ADDENDUM No. 1

RFP No. 25-57

SOUTH MAPLE PARK AND DEXTER PARK IMPROVEMENTS

SHEET# 9 OF 12
JOB No: 2300405

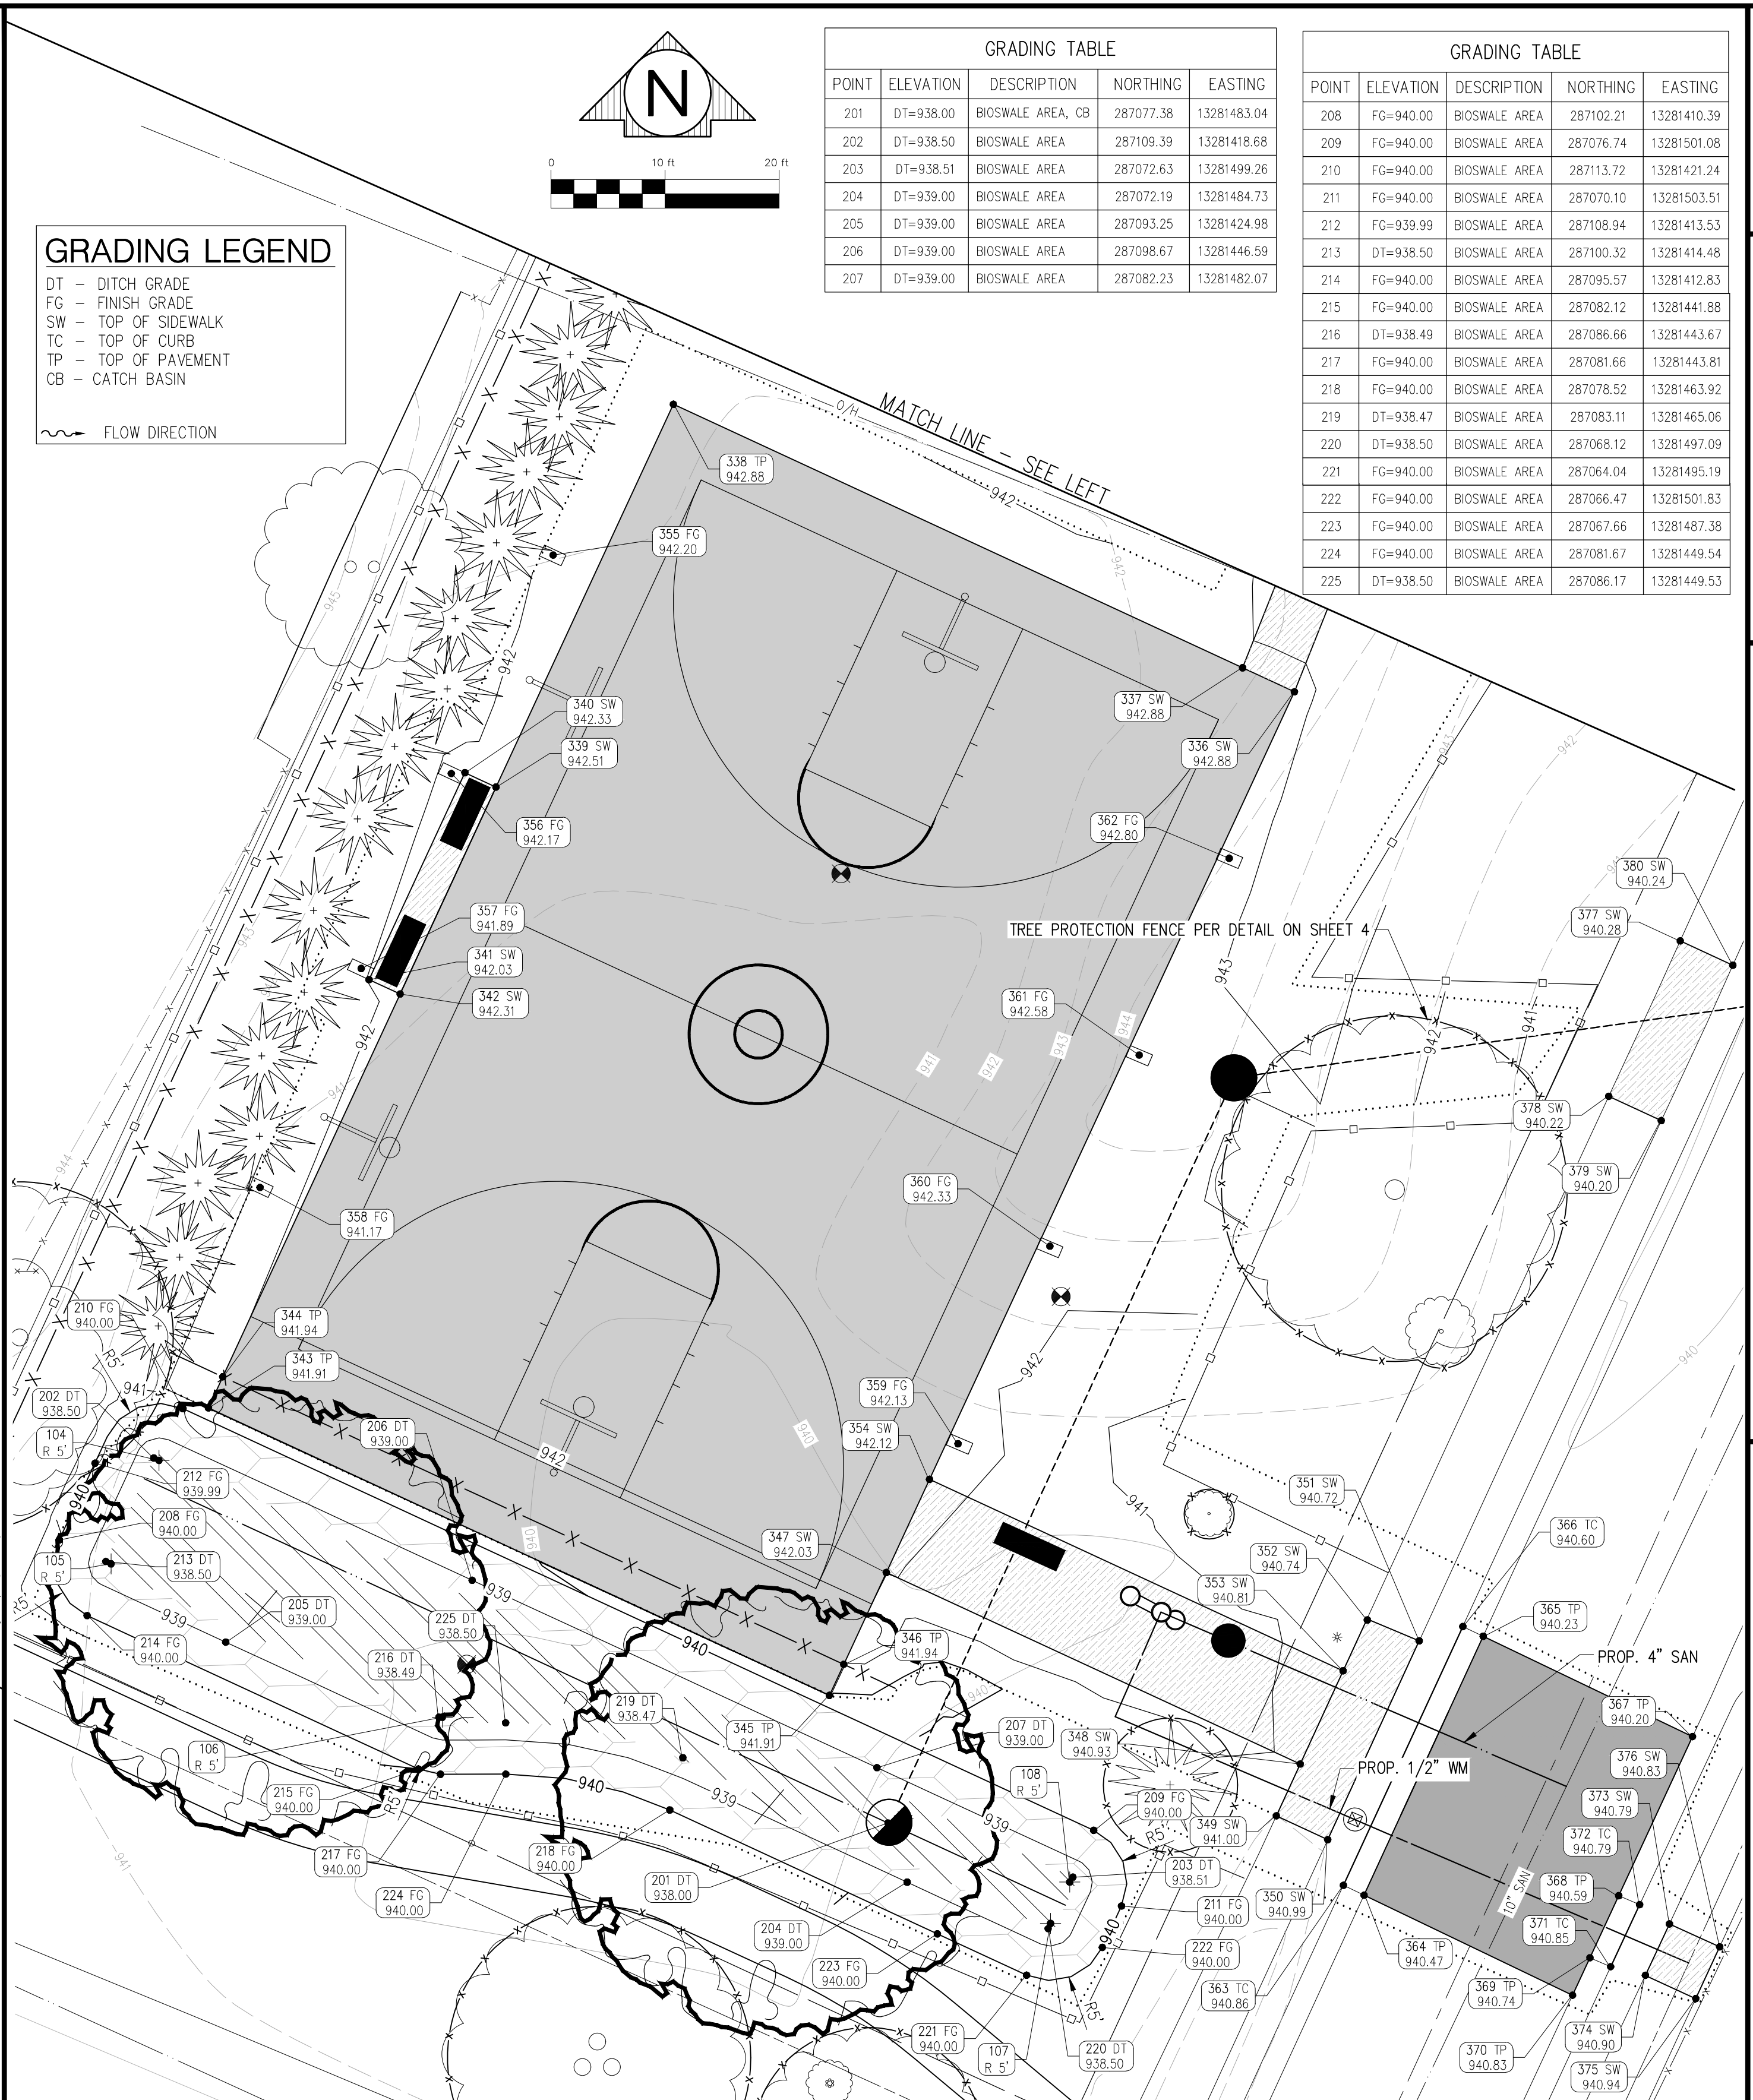
Section/Page(s)	Change
Schedule of Pricing / Cost	Schedule of Pricing/ Cost has been replaced in its entirety
Detailed Specifications Section 01 71 23.15	Detailed Specification 01 71 23.15 Construction Staking has been replaced with 01 71 23.16 Construction Staking by Contractor.
Site Plan Sheet 8	Site Plan Sheet 8 has been replaced in its entirety.
Grading Sheet 9	Grading Sheet 9 has been replaced in its entirety.
Architectural Plans A-1, A-2, A-3	Addition of the architectural plans for the Dexter Park Pavilion have been included in this addendum. See Sheet A-1, A-2, A-3.
Cut/Fill Calculations	Addition of Cut/Fill Calculation Sheets for reference purposes only. Contractor is responsible for calculating their own quantities.

SHEET NO.: A-1

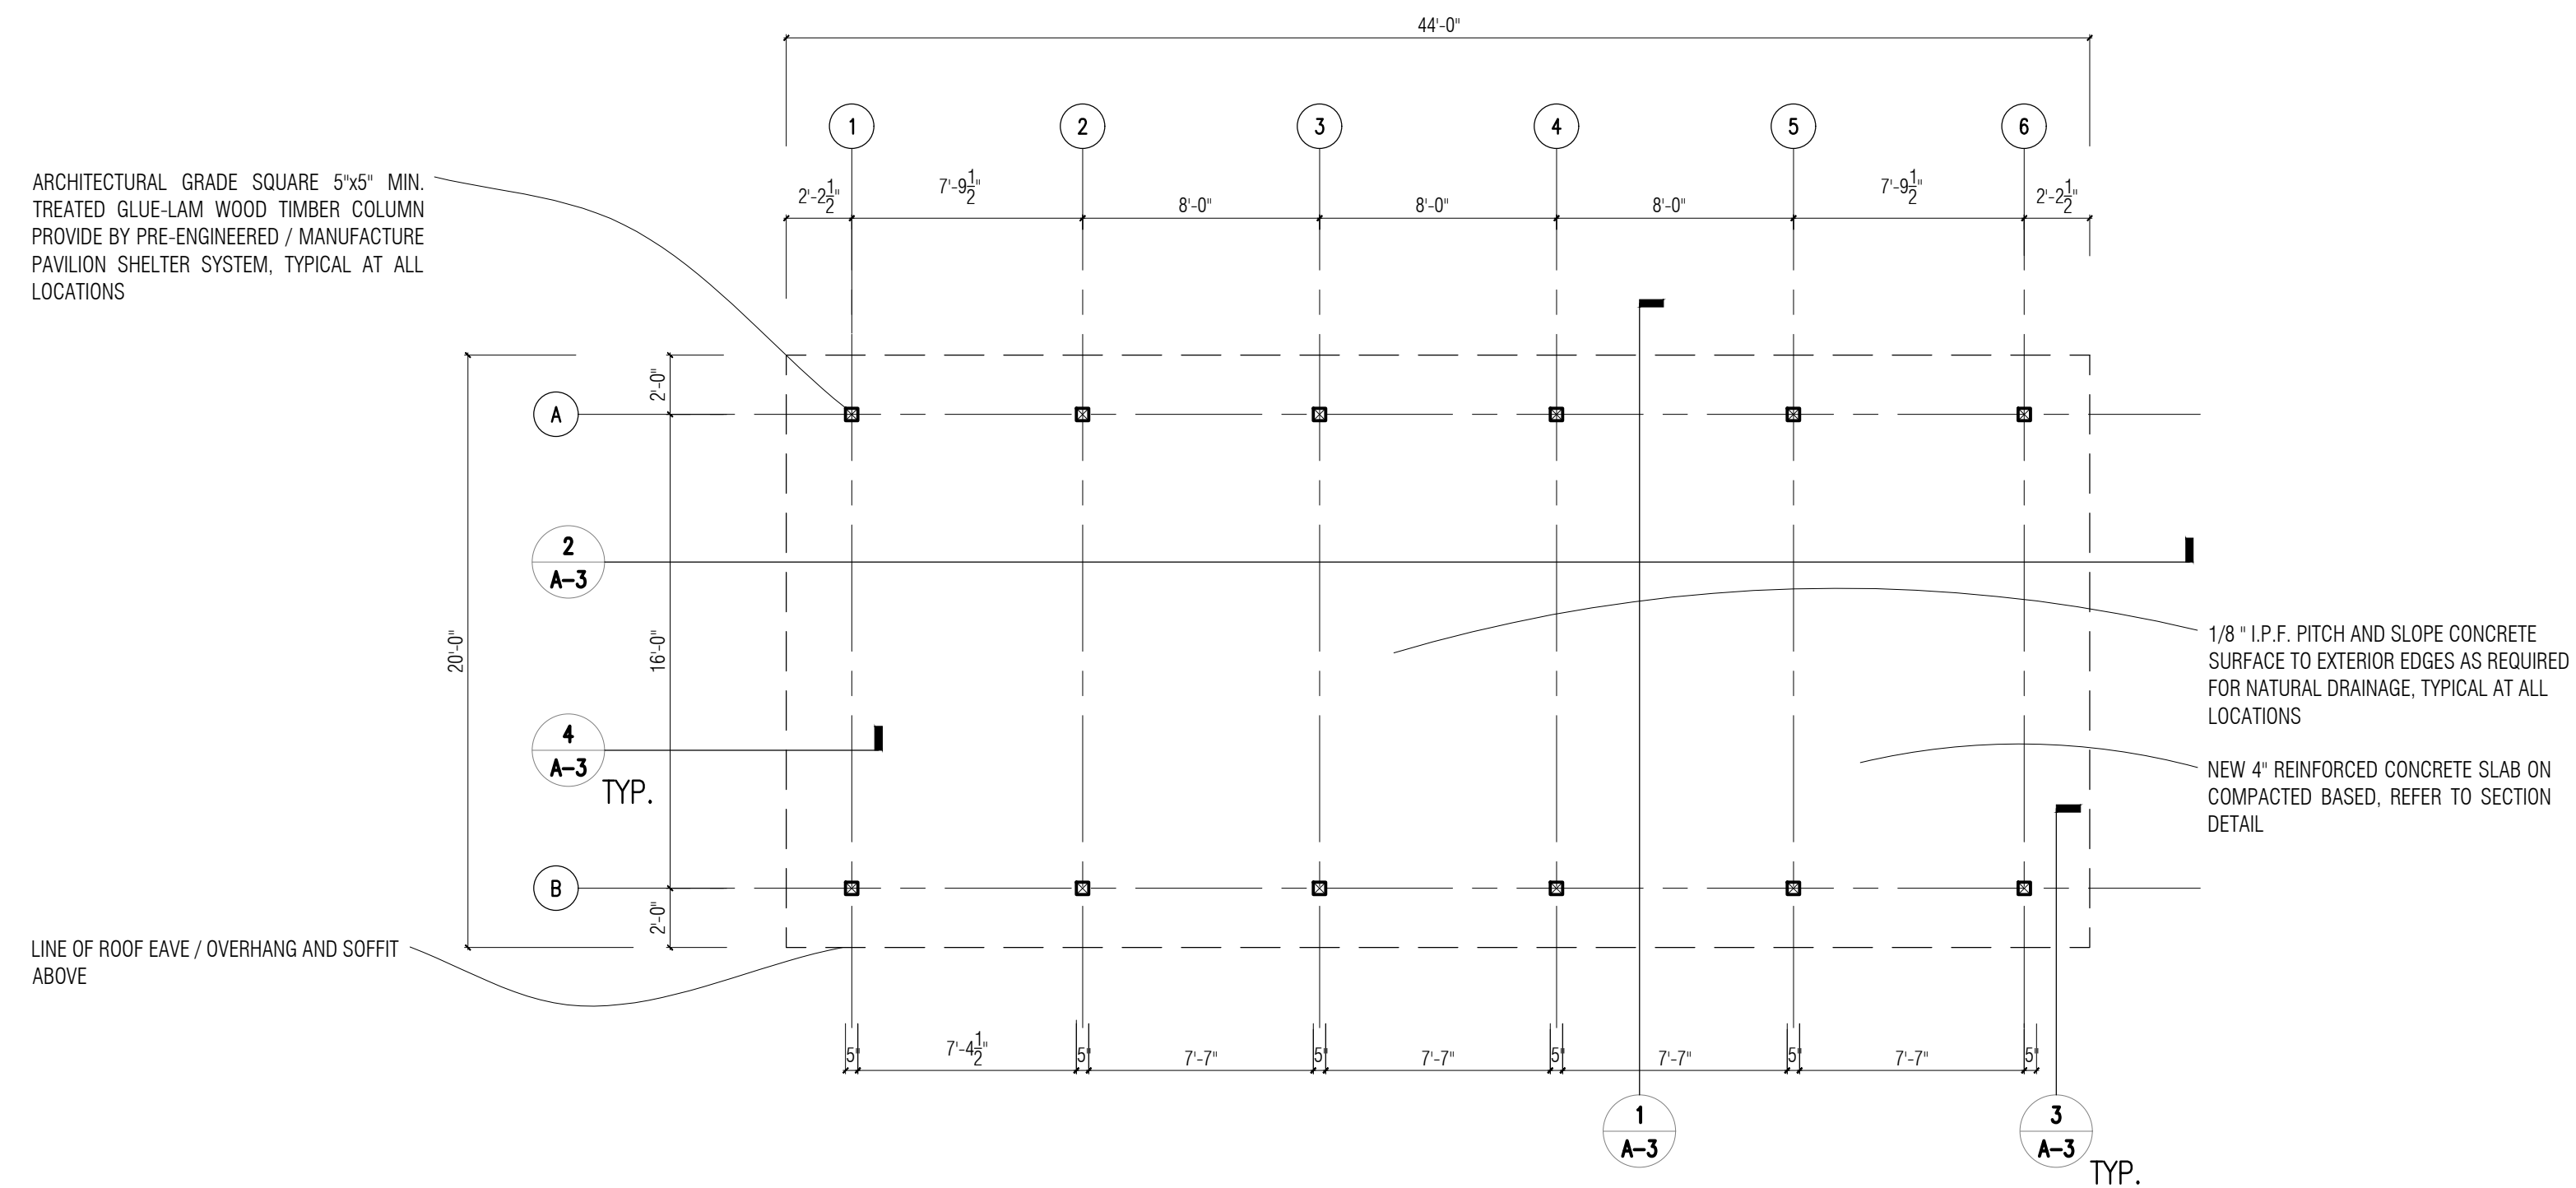
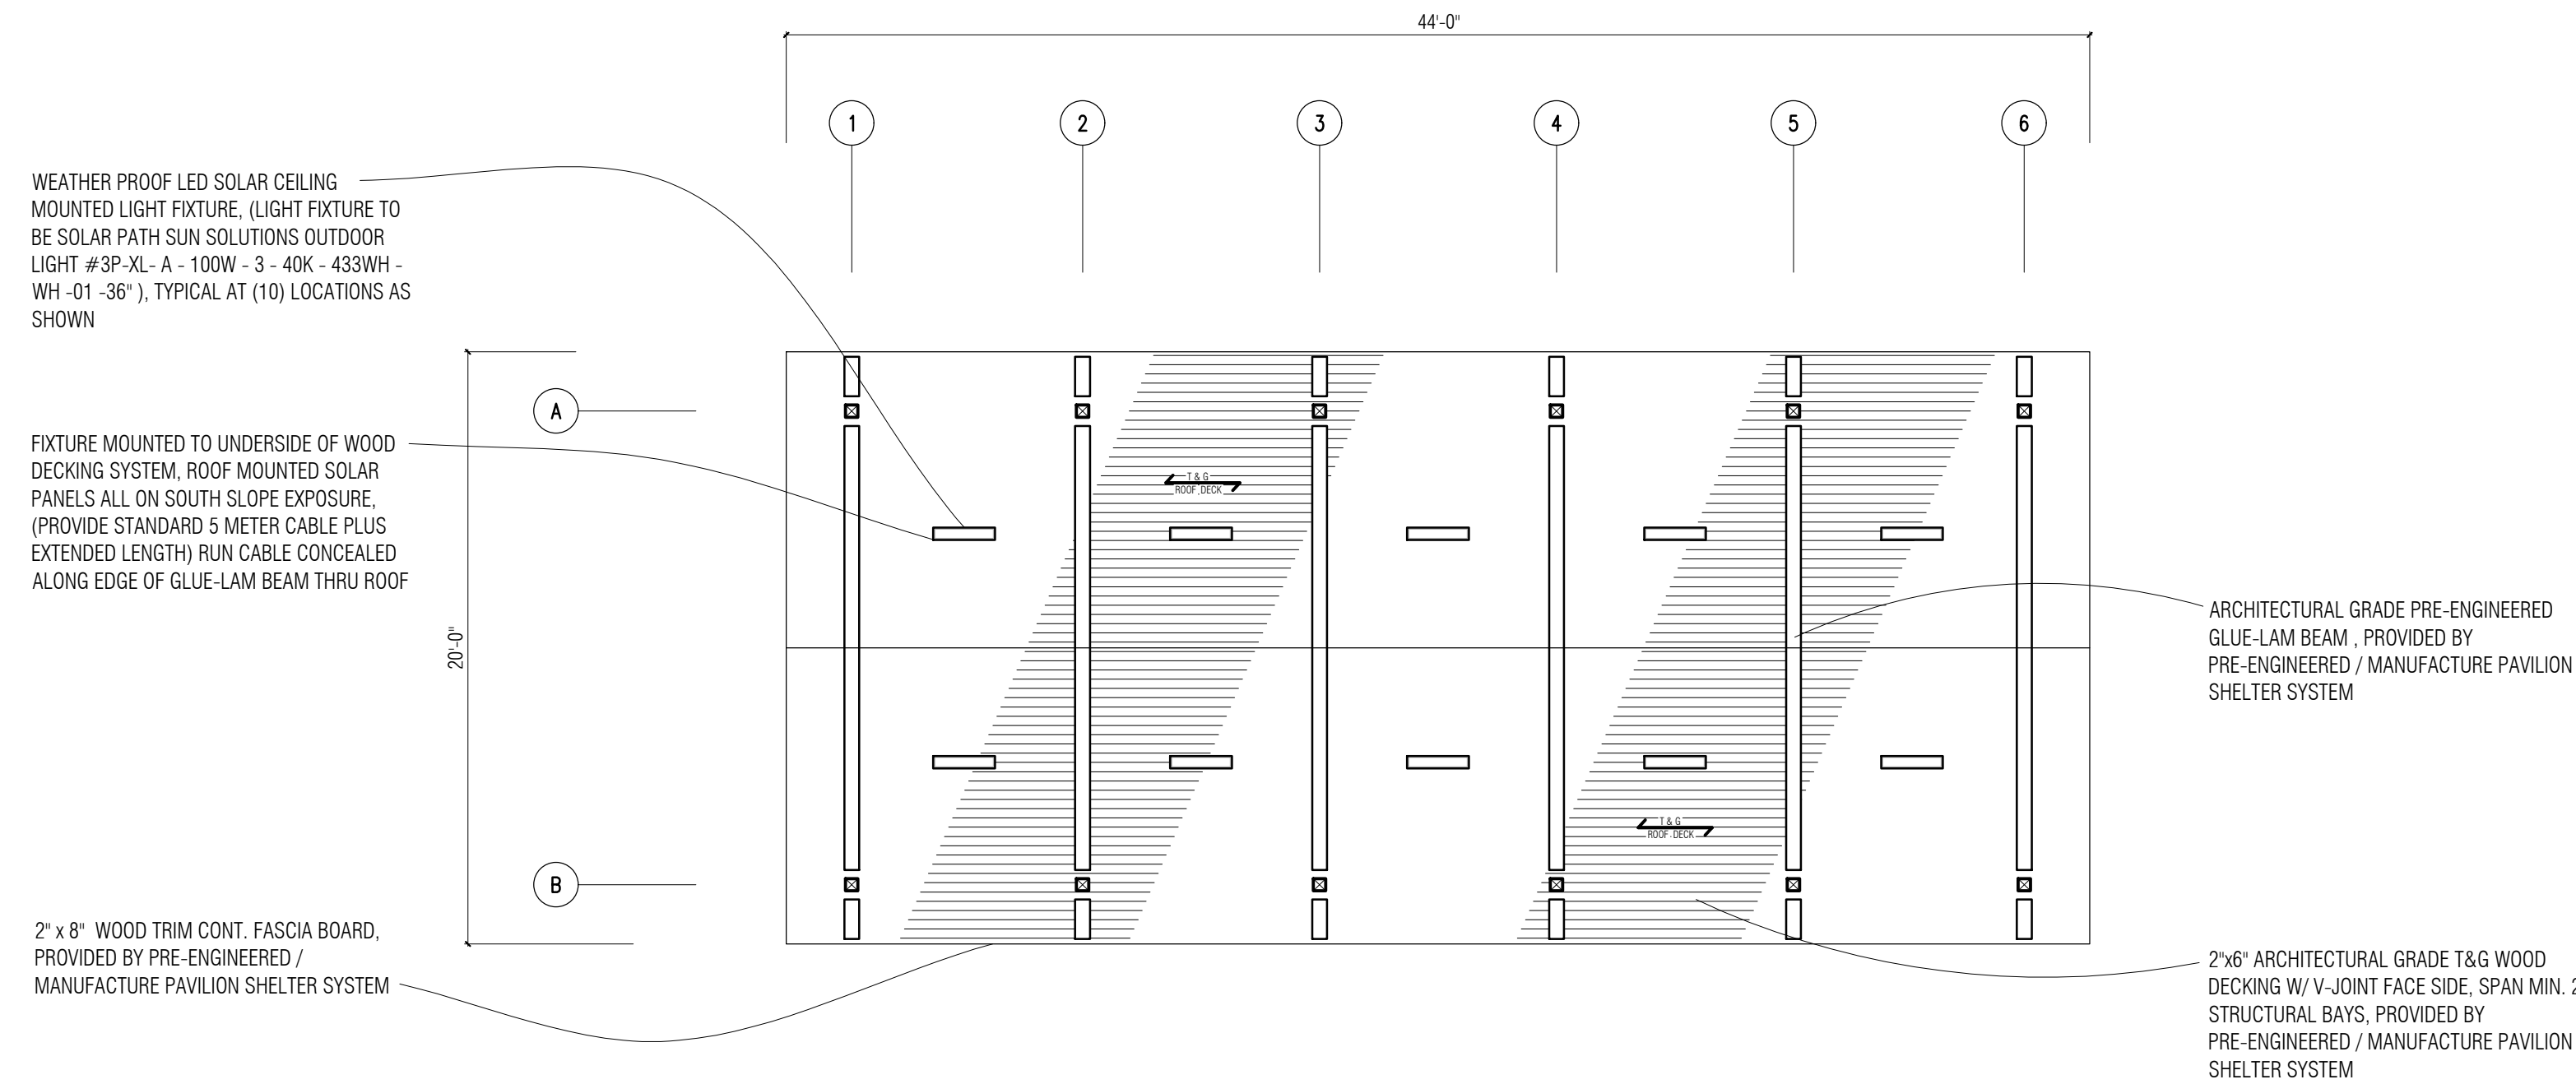
Question 3: Will the architectural plans for the pavilion at Dexter Park be issued as an addendum?

Question 12: How is the concrete pad under the Dexter Park Pavilion being paid for?

Answer 3: Yes, the architectural plans for the pavilion at Dexter Park are included in this addendum.

Answer 12: The 22'x 46' concrete pad per the architectural plans will be paid for in Item # 6 in the Schedule of Pricing / Cost for Dexter Park.
